THE SHOPPES AT HIGHLAND CREEK
CHARLOTTE, NORTH CAROLINA
A PROJECT PROPOSED BY:
THE CROSLAND GROUP, INC.
227 WEST TRADE STREET SUITE 800
CHARLOTTE, NORTH CAROLINA 28202
AND
CHILDRESS KLEIN PROPERTIES
2800 ONE FIRST UNION CENTER
301 SOUTH COLLEGE STREET
CHARLOTTE, NORTH CAROLINA 28202

TECHNICAL DATA SHEET

FOR PUBLIC HEARING
PETITION # 00-134

SUBJECT: Administrative Approval for Petition No. 2000-134 by Highland Creek Retail.

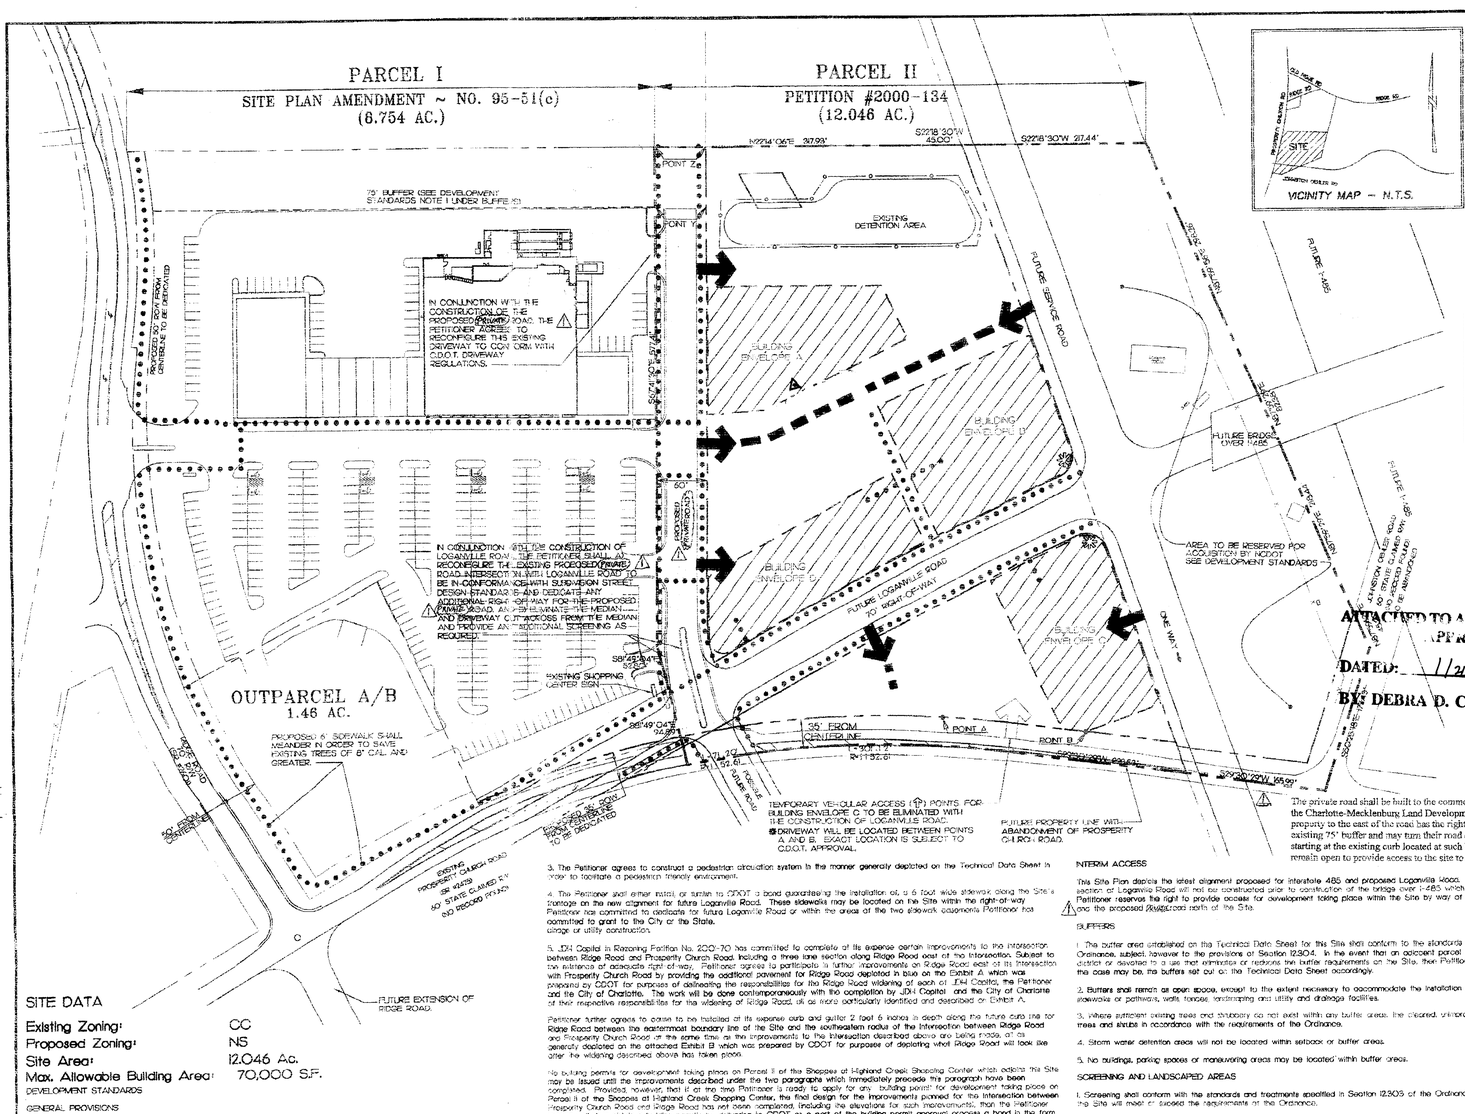
Attached are revised plans for the above petition. The plans have been revised to make minor changes to the sidewalk for building envelope A, parcel 02931134. The sidewalk in front of the proposed building along the private drive is being removed. A painted pedestrian crosswalk to the sidewalk on the adjacent property is being added. All other sidewalks associate with building envelope A will remain. Since these changes are minor and do not alter the intent of the development and meet the requirements of the Charlotte Zoning Ordinance Section 6.207 Alterations to Approval, minor changes, I am administratively approving these plans. Please use these plans when evaluating request for building permits and certificates of occupancy.
